To: eis_office@ymp.gov
cc: "Ron Damele" <rdamele@eurekanv.org>
Subject: Eureka County EIS Comments - Part One

**Comments of Eureka County, Nevada
Regarding U.S. Department of Energy's
Draft Supplemental Environmental Impact Statement for the Yucca Mountain
Repository, Draft Supplemental Environmental Impact Statement for the Nevada
Rail Transportation Corridor, and
Draft Environmental Impact Statement for a Rail Alignment:**

TYPICAL SECTION - LARGE FILL
(SEE SHEET 3 OF 21 FOR TYPICAL TRACK DETAILS)

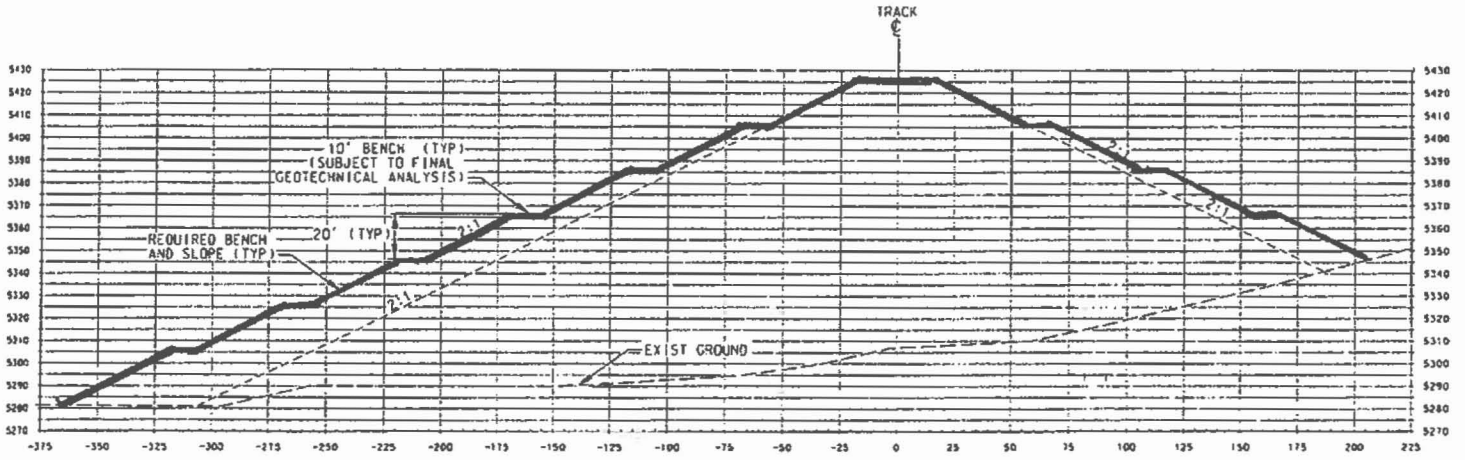
- 21 [There are also many inconsistencies within the description. For example, in some places DOE states that the right-of-way won’t be fenced, but in other places it states that the right-of-way fencing will be determined by BLM. The “nominal width” of the operations right-of-way is stated as being 400 feet in the text (Rail Alignment Draft EIS at 2-5), but a DOE reference document indicates that the right-of-way width varies significantly, to a maximum width of 1,000 feet. Draft SEIS Reference Document # DIRS 182824. The right-of-way width in the area of a large cut would be 480 feet and in the area of a large fill would be 575 feet. *Id.*]]

- 22 [Although in some parts of the Draft EIS the DOE recognizes that cut and fill slopes will result in disturbed areas that are wider than 400 feet, it provides no information that would allow the reader to determine where these areas are. The maps provided in the on-line map atlas are only satellite images, and do not provide contours to allow the reviewer to estimate areas where significant cuts and fills may be required.]
